## PIC16CR65 Rev. A Silicon Errata Sheet

The PIC16CR65 parts you have received conform functionally to the Device Data Sheet (**DS30234D**), except for the anomalies described below.

## Clarifications/Corrections to the Data Sheet:

**FIGURE 1: WRITES TO TIMER1 (EXTERNAL CLOCK / OSCILLATOR MODE)**

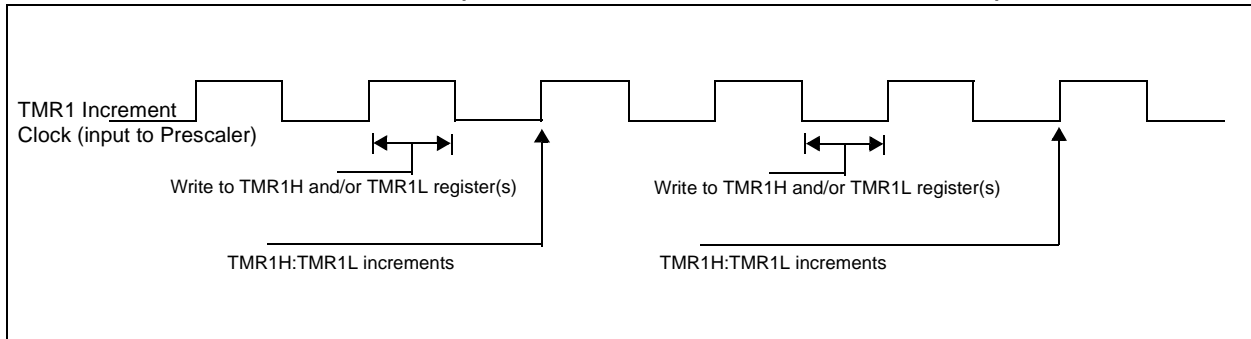
- a) The operation of Timer1 needs some clarification when the timer registers are written when the TMR1ON bit is set.

The internal clock signal that is the input to the TMR1 prescaler affects the incrementing of Timer1 (TMR1H:TMR1L registers and the Timer1 prescaler). When the Timer1 registers are NOT written, the Timer1 will increment on the rising edge of the TMR1 increment clock.

When the TMR1H and/or TMR1L registers are written while this clock is high, TMR1 will increment on the next rising edge of this clock.

When the TMR1H and/or TMR1L registers are written while this clock is low, TMR1 will not increment on the next rising edge of this clock, but must first have a falling clock and the the rising clock for TMR1 to increment.

Figure 1 shows the two cases of writes to the TMR1H and/or TMR1L registers. Due to the V<sub>IH</sub> and V<sub>IL</sub> thresholds on the oscillator/clock pins, external Timer1 oscillator components, and external clock frequency, the Timer1 increment clock may not be of a 50% duty cycle.

The TMR1 increment clock is out of phase of the T1OSO/T1CKI pin by a small propagation delay.
